**HISTORIC PRESERVATION REVIEW BOARD  
STAFF REPORT AND RECOMMENDATION**

Landmark/District: **Foggy Bottom Historic District** (x) Agenda  
Address: **2507 I Street NW**

Meeting Date: **December 20, 2018** (x) Alteration  
Case Number: **19-040** (x) Concept

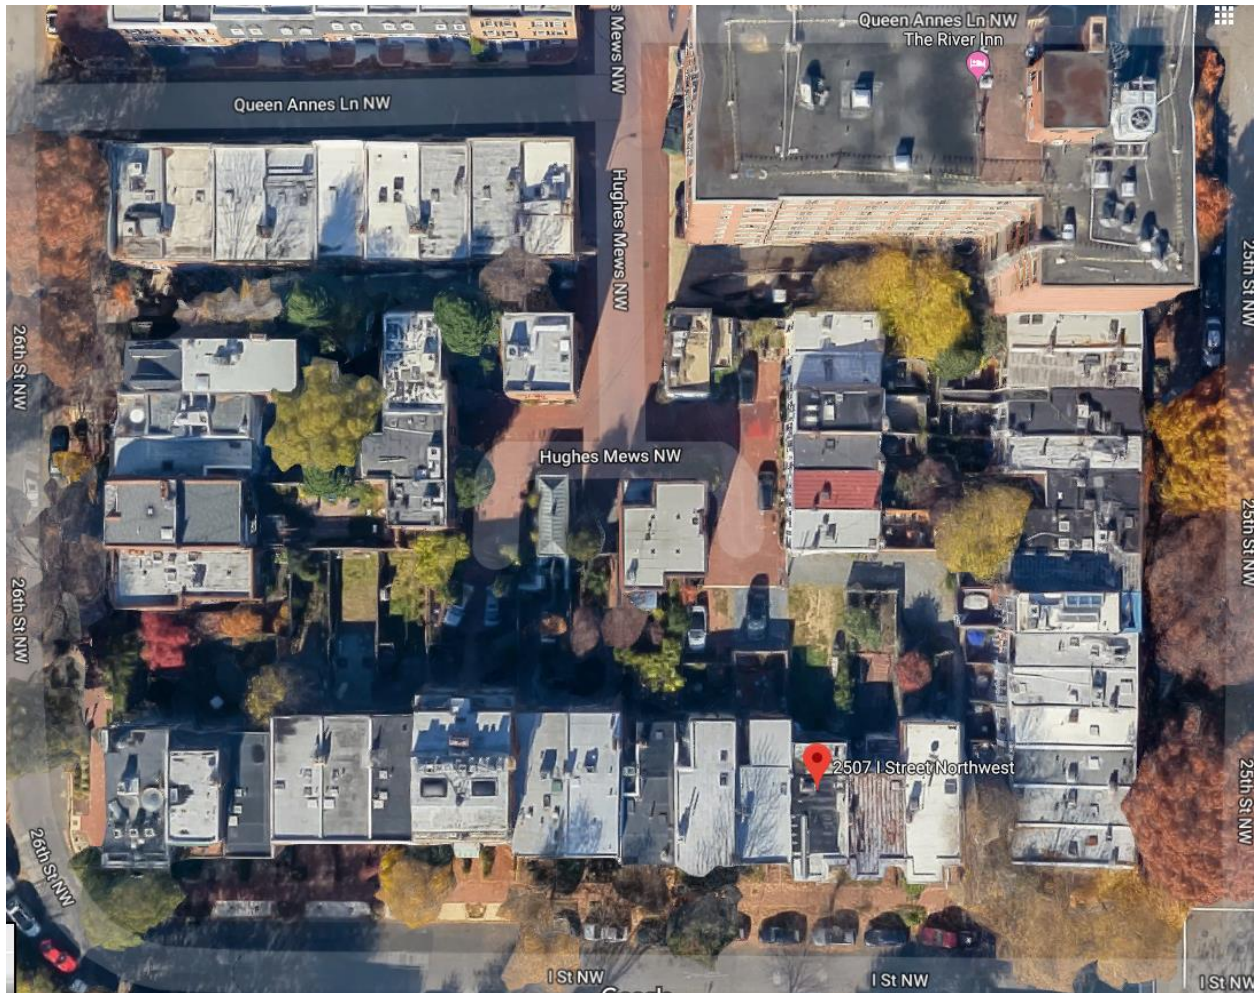
The addition would more than double the depth of the building, taking it from about 27 feet to 59 (not counting the front bay projection into public space). This would make it the deepest building on this side of the street, even accounting for the various setbacks of the houses. The other houses have been little altered in terms of extensions, as can be seen from the aerial photo below.

The addition would not only be deeper than, but also taller than, the subject house and its neighbors. This is incompatible, as the volume of the addition would overwhelm the smaller main block and those of adjacent properties. It would create an odd massing that reverses a traditional hierarchy of telescoping down toward the rear. A two-story house typically has a two-story wing, but often only a one-story one and almost never a three-story. This is certainly true of Foggy Bottom, with an exception discussed below.

*HPO recommends that the Board approve the concept as retaining the character of the house and as compatible with the character of the historic district, with the conditions that:*

- 1. the addition be of two stories, not three;*
- 2. the façade's door and window configurations be revised;*
- 3. the floor framing not be demolished;*
- 4. the original front-yard grade be restored; and*
- 5. further review of the project be delegated to staff.*
